SEAD-59 AND SEAD-71

PROJECT SCOPING PLAN FOR PERFORMING A CERCLA
REMEDIAL INVESTIGATION/FEASIBILITY STUDY (RI/FS) AT
THE FILL AREA WEST OF BUILDING 135 (SEAD-59), AND THE
ALLEGED PAINT DISPOSAL AREA (SEAD-71), SENECA ARMY
DEPOT ACTIVITY

APRIL 1997

**PROJECT SCOPING PLAN
REMEDIAL INVESTIGATION/FEASIBILITY STUDY
AT SEAD-59 and SEAD-71
SENECA ARMY DEPOT ACTIVITY
ROMULUS, NEW YORK**

**FIGURE 3-15
 GROUNDWATER ELEVATION MAP**

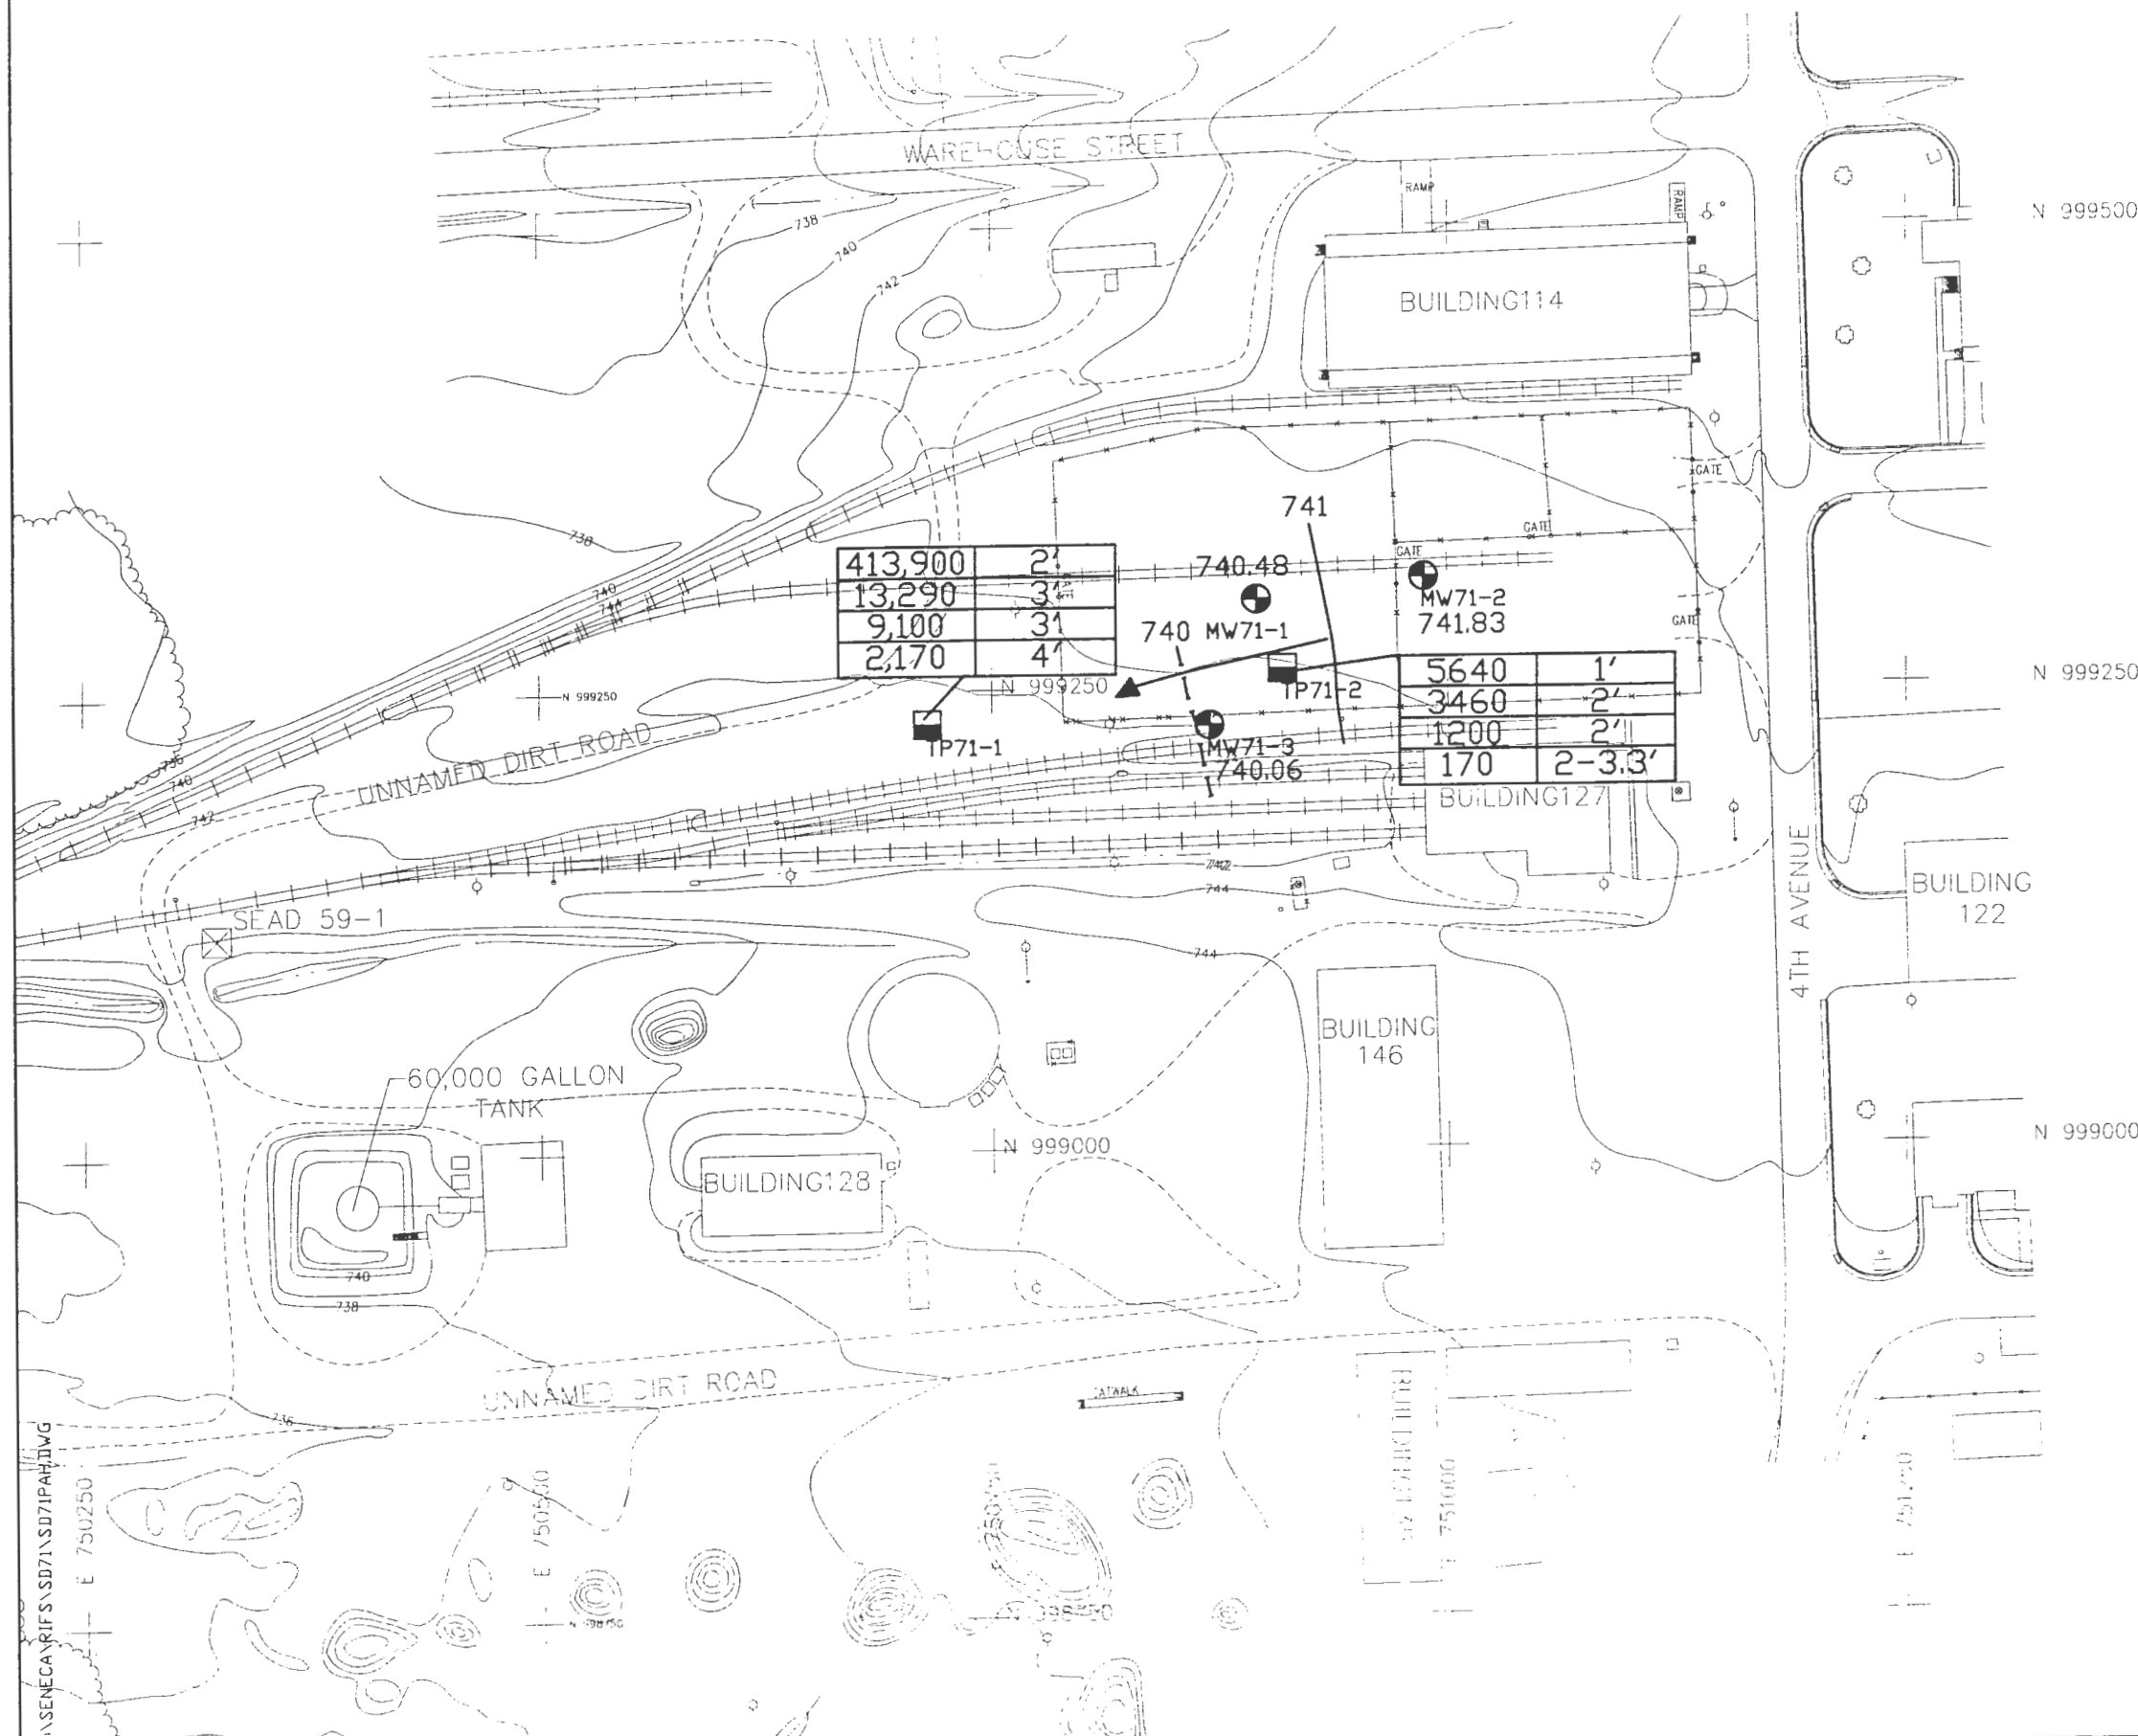
Figure 3-19: It is unclear what control was used to construct the 740 foot contour line presented on this figure.

Figure 3-20: See comment for Figure 3-19. The construction of the groundwater contours in Figure 3-20 is not consistent with Figure 3-19. In general, even though the contour lines are dashed on Figure 3-20 to indicate that they are inferred, they extend well beyond any control points.

- Response #7** Agreed. The groundwater contours in Figure 3-16 (formerly 3-20) have been revised so that they are the same as those shown in Figure 3-15 (formerly Figure 3-19).

FIGURE 4-1
 LOCATION OF EXISTING AND
 PROPOSED SAMPLING POINTS

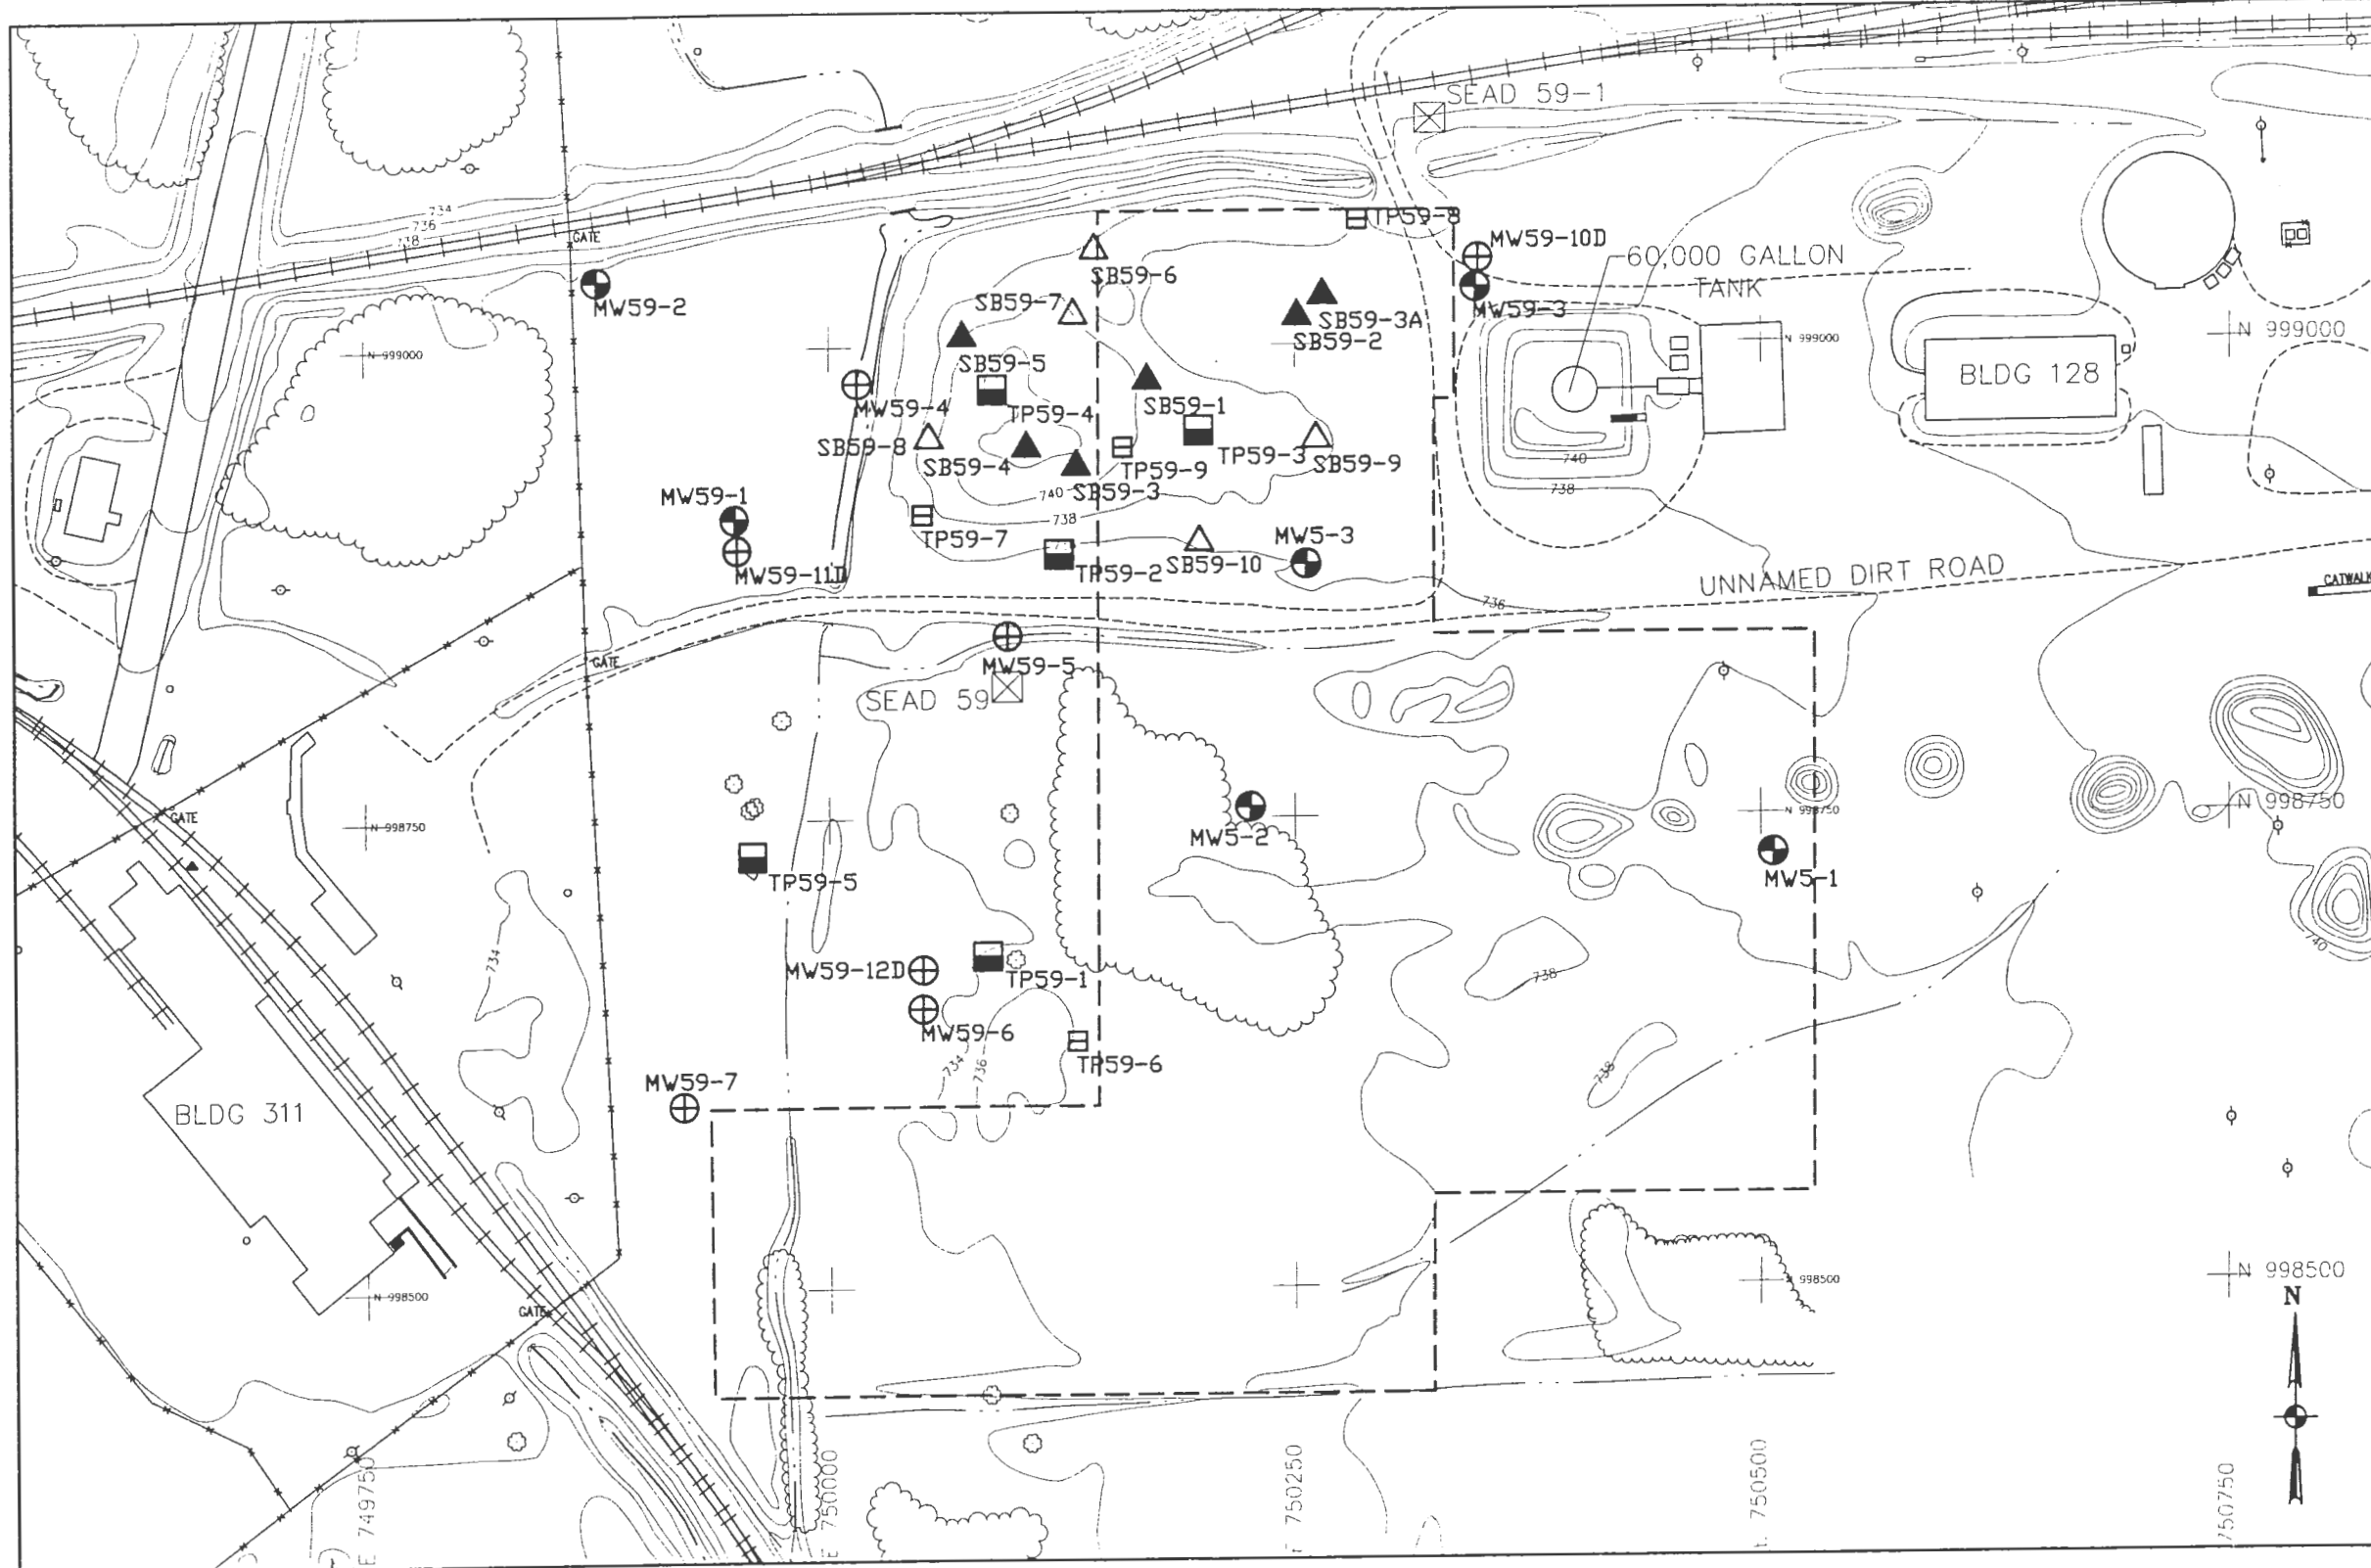
- Comment #19** Figures 4-3: As with Figure 4-5, groundwater contours should be shown on this Figure. Also the locations of monitoring wells MW5-1, MW5-2, and MW5-3 should be shown on this Figure as they are on Figures 3-11 and 3-12. The rationale for the proposed location of monitoring well MW59-6 should be provided. The proposed location for this well is approximately 60 feet from Test Pit TP59-6 in which 2,100,00 ug/kg of BTEX was present. Proposed well MW59-6 should be moved next to this test pit in order to better characterize groundwater quality in this area.

- Response #16** Agreed. To address possible vertical impacts at the site three (3) shallow bedrock monitoring wells have been proposed. Two of the bedrock wells are proposed in downgradient locations and one is proposed as a background location. The text in Section 4.2.5.1 and Figure 4-1 were revised to reflect this change in the field program.

- Response #19** Agreed. The wells MW5-1, MW5-2, and MW5-3 were added to this figure. Also, well MW59-6 was moved so that it is closer to test pit TP59-6 as recommended in the comment. But, we do not believe that it is necessary to show the groundwater contours on this map because this would make the map look cluttered and more difficult to read; however, the groundwater contours are shown on Figure 3-7. The location of this well on Figure 4-1 was revised.

Response #1 Agreed. The Scoping Plan currently calls for a till/weathered shale well near TP59-1, and based on EPA comments this wells has been moved even closer to the test pit location; also, a bedrock well is proposed for this location as well. Because the comment suggests that multiple wells will be necessary to define the extent of the possible VOC impacts in groundwater, another well has been proposed to be installed even farther downgradient of TP59-1, near the SEAD-59 boundary. The text in Section 4.2.5 was revised as well as Figure 4-1.
